Remove/Replace Plumbing and Life Safety Systems, Grand Mesa Youth Services Center
IFB 2025000178

Questions and Answers

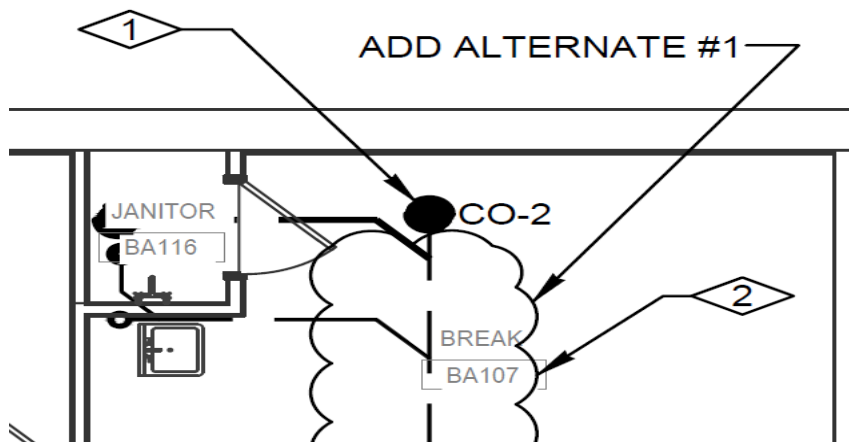
1. Limited work hours per day (8-4:30), depth of existing underground and new will impact productivity rates and overall schedule to complete each phase. Please provide depth of underground at the various locations, reference PU1-1 and PU1-2.
 - a. Depth to be verified-in-field by general contractor prior to start of work.
Drawings indicate general location of lines and are diagrammatic representations of work to be performed.
2. PU1-2, underground scope reflects existing line between CO-18 and CO-19. Please confirm this is to remain and courtyard turf shall not be disturbed.
